Access Compliance Report

Public Rights-of-Way (Curb Ramps)

Intersection ID: 51011	Main Street: TREMONT_PLACE_RD	Cross Street: BENDING_BRANCH_RD	Location: NW
ADA ID: 0FEDABFA352B	Ramp Type: Perp	Initial Pass/Fail: Fail	Overall Compliance: No
Severity Score: 22.5			
Codes/Mitigation Info/Possible Solution		Field Measurements/Component Compliance

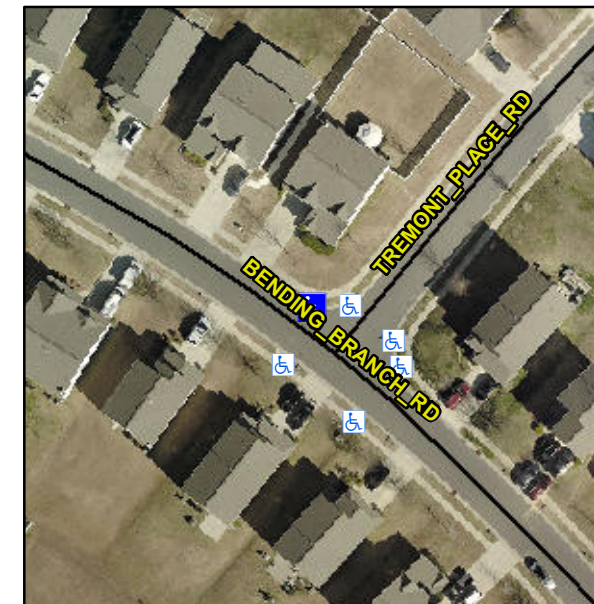
Not Found, R304.5.1, R304.2.2, R304.5.3

Compliance	Description	Data	Compliance	Description	Data
N/A	Ramp Length (in)	47.0	No	Ramp Slope (%)	11.1
No	Ramp Width (in)	47.5	No	Ramp XSlope (%)	4.0
N/A	Flare Type LT	N/A	N/A	Flare Type RT	N/A
N/A	Flare Slope LT (%)	N/A	N/A	Flare Slope RT (%)	N/A
N/A	Flare Traversable LT?	N/A	N/A	Flare Traversable RT?	N/A
N/A	Landing Length (in)	N/A	N/A	DWS Provided?	N/A
N/A	Landing Width (in)	N/A	N/A	DWS Contrast?	N/A
N/A	Landing Slope (%)	N/A	N/A	DWS Length (in)	N/A
N/A	Landing X Slope (%)	N/A	N/A	DWS Full Width?	N/A
N/A	Landing Curb? (Y/N)	N/A	N/A	DWS Offset (in)	N/A
N/A	Shared Landing?	N/A			
N/A	Gutter Ponding?	N/A	N/A	Gutter Slope (%)	N/A
N/A	Gutter Lip Ht (in)	N/A	N/A	Gutter X Slope (%)	N/A
N/A	Painted X Walk1?	No	N/A	Painted X Walk2?	N/A
	X Walk 1 Direction	To S		X Walk 2 Direction	N/A
N/A	X Walk 1 Width (in)	N/A	N/A	X Walk 2 Width (in)	N/A
	X Walk 1 Slope (%)	3.0		X Walk 2 Slope (%)	N/A
	X Walk 1 X Slope (%)	2.2		X Walk 2 X Slope (%)	N/A

Remove & Replace Entire Ramp.
